Access Compliance Report

Public Rights-of-Way

(Curb Ramps)

Intersection ID: 31490	Main Street: BULLOCK_DR	Cross Street: CLOVER_GAP_DR	Location: W
ADA ID: 8F5A68552803	Ramp Type: BlendTrans1	Initial Pass/Fail: Fail	Overall Compliance: No
		Severity Score: 8.75

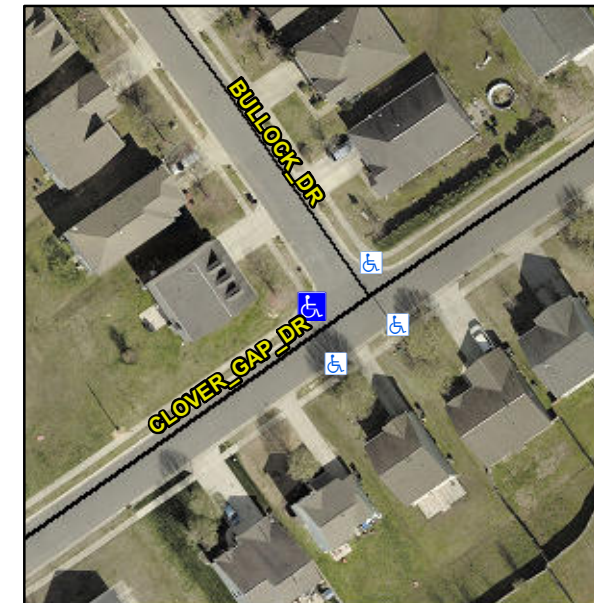
Not Found, R304.5.1

Remove & Replace Curb Ramp With Two New Directional Ramps or Equivalent.
